Bulletin No.	07-001	Issue Date:	30/01/2007
Issue/Revision:	02	No. of Pages:	6
Prepared By:	D.C. Lawes	Signature/Date:	 30/01/07.
Approved By:	S.C. Partridge	Signature/Date:	 30/01/07.

Subject: ROVNAV Connectors

Photographs showing sealing surfaces (locking sleeve retracted)

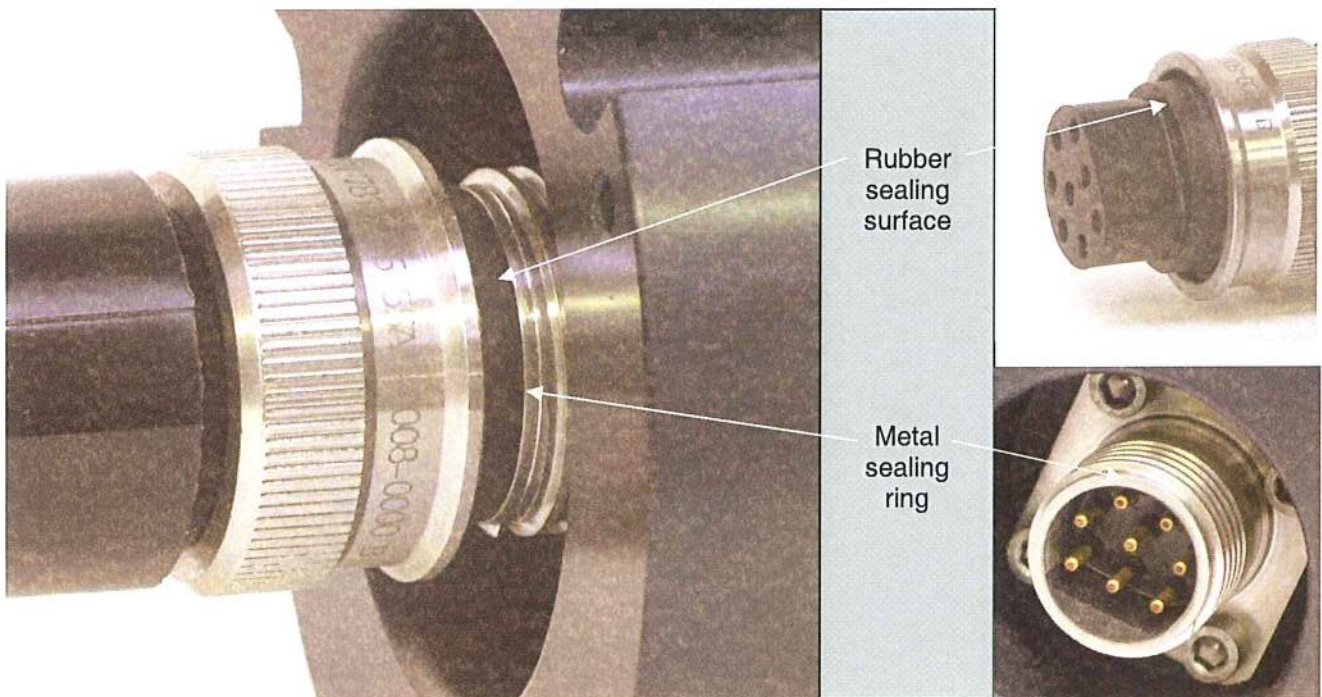
The new cable connector moulding allows the connector to be fully tightened and then for the locking sleeve to be retracted, allowing a visual inspection of the mating surfaces. The main seal is formed by the outer ring of the rubber moulding of the cable connector being in close contact with the outer metallic ring of the bulkhead connector. It is therefore vitally important that these parts are clean and undamaged. The photographs below show the old cable connector and the new design.

In the photographs below, the old and new cable moulding designs are compared. In the left-hand photo, the new design (at the rear) can be recognised by the longer neck of the connector before PU moulding begins

The right-hand photo shows the improved visibility of the rubber sealing parts when the locking sleeve is retracted.

Once the connector has been fully tightened, the locking sleeve can be retracted to ensure that the sealing surfaces shown below are in contact.

New Transducer endcap

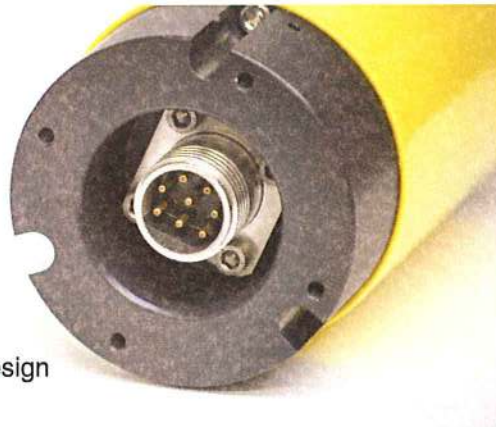
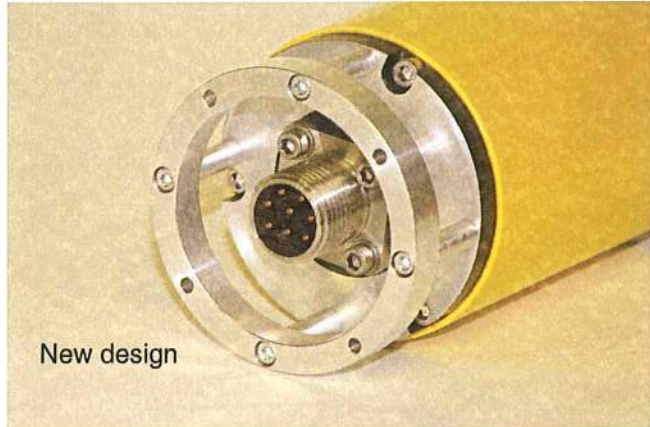
The new transducer endcap design provides improved access for tightening the connector with improved visibility of the mated connector in conjunction with the retractable locking sleeve. The new guard design still provides protection for the connector when it is disconnected and removed from its normal mounting position on the ROV.

The new design on the right shows the increased access space for fingers, facilitating the locking sleeve to be fully tightened.

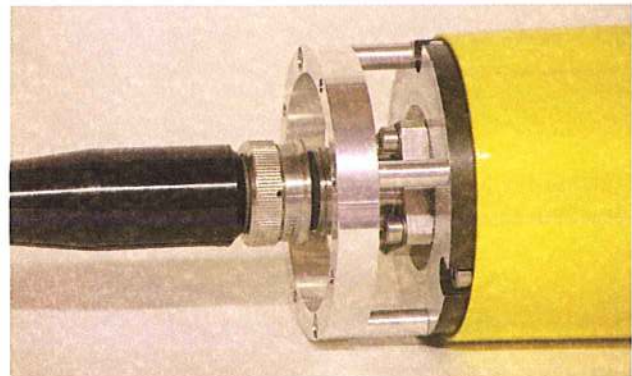
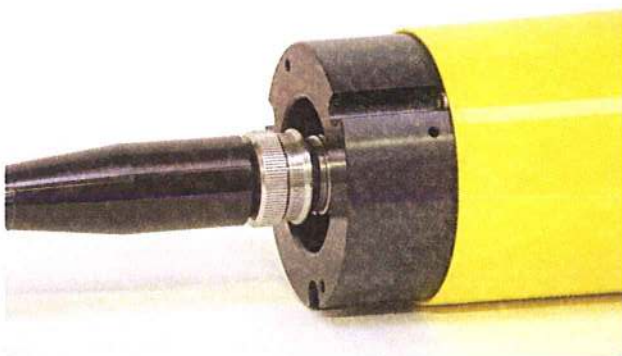
The photos below show the improved visibility of the mating surfaces with the locking ring retracted.
